AEM 495 MEMO

Subject: Preliminary aerodynamics analysis of an unofficial Cessna Citation geometry

Memo: AEM495-14-M02

REF: Citation2-v4.CATPart

Figure 2: Canopy Loft Issue

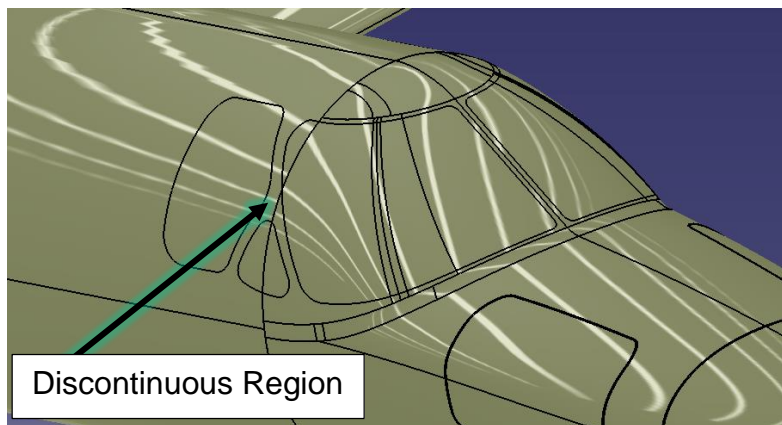
A significant loft issue in the canopy area was spotted with zebra lighting (see Figure 2) at the intersection of the cylindrical fuselage and the complex canopy surface. From the zebra lighting, this region does **not** appear to be either tangentially or curvature constrained. **This canopy loft issue will appear as a local accelerated flow region with detrimental downstream separation.** A comparison with the actual Citation surface reveals that the current CAD model poorly represents reality.

Figure 3: Mach 0.40 Streamlines

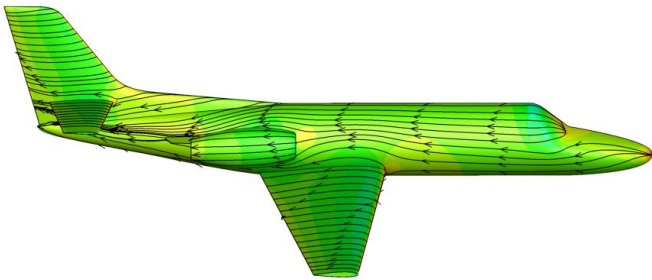
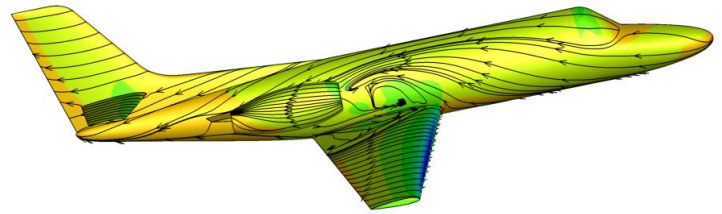
The aircraft already shows undesirable characteristics at Mach 0.40. Figure 3 shows the streamlines at 0 and 10 degrees angle of attack. Overall, the flow is attached at 0 AOA. The wing-fuselage intersection has significant issues with local flow (e.g. the stagnation point at the root is several inches along the upper wing surface); **a wing glove is needed**. The previously mentioned canopy loft issue appears as a faint blue area in the pressure contour; no separation appeared at Mach 0.40.

At 10 degrees AOA, a separated region appears in the wing root area. Unfortunately, this separation is likely to have a strong negative impact on the jet intake. At higher power settings and higher AOAs, strong separation will likely be entrained by the intake. Again, a **careful redesign of the wing root region** will be required.

Figure 4: Pylon Streamlines and Pressures (Mach 0.40, 0 AOA)

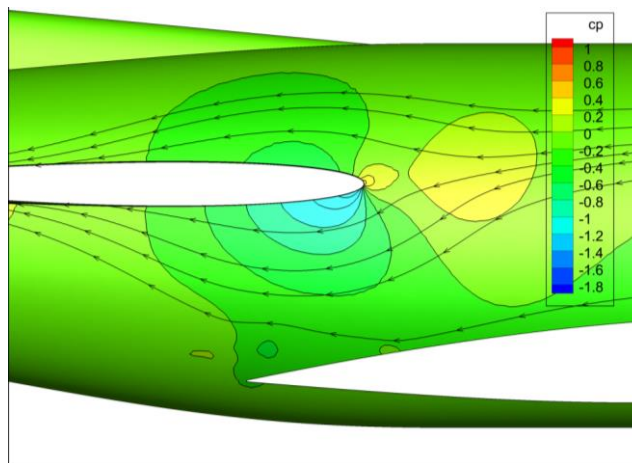
The pylon region connecting the engine nacelle and the aft fuselage also exhibited poor aerodynamic behavior. Figure 4 shows the streamlines and pressure contours on the aft fuselage in the pylon region at Mach 0.40 and 0 AOA. The pylon is situated in a downwash region of the aft wing, resulting in an excessive suction peak on the lower surface. At other conditions, a shock appeared in this area. **The pylon must be redesigned.**

Figure 5: Mach 0.80 0 AOA Streamlines and Cp Contours

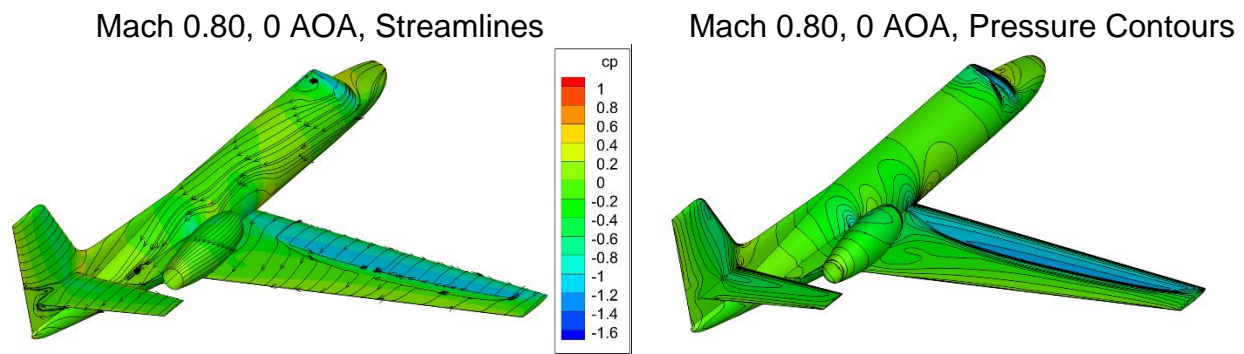
Testing at Mach 0.80 brought out additional aerodynamic issues. At 0 AOA, a strong shock is seen on the wing, upper pylon, upper canopy, and lower horizontal. See Figure 5 for streamlines and pressure contours at Mach 0.80 and 0 AOA. The upper canopy region is particularly bad. The adverse pressure gradient (i.e. shock) associated with the non-tangential surface produces a strong separation region. This local shock and separation will produce excessive noise and vibration on the aircraft.

The wing pressure contours indicate that the airfoil cross sections are likely from the classical NACA series. **These current airfoils are potentially unsatisfactory for high subsonic transport aircraft.** Also, these airfoils appear to contribute to the detrimental degradation in the pitch stability in the Mach 0.70 to Mach 0.90 range.
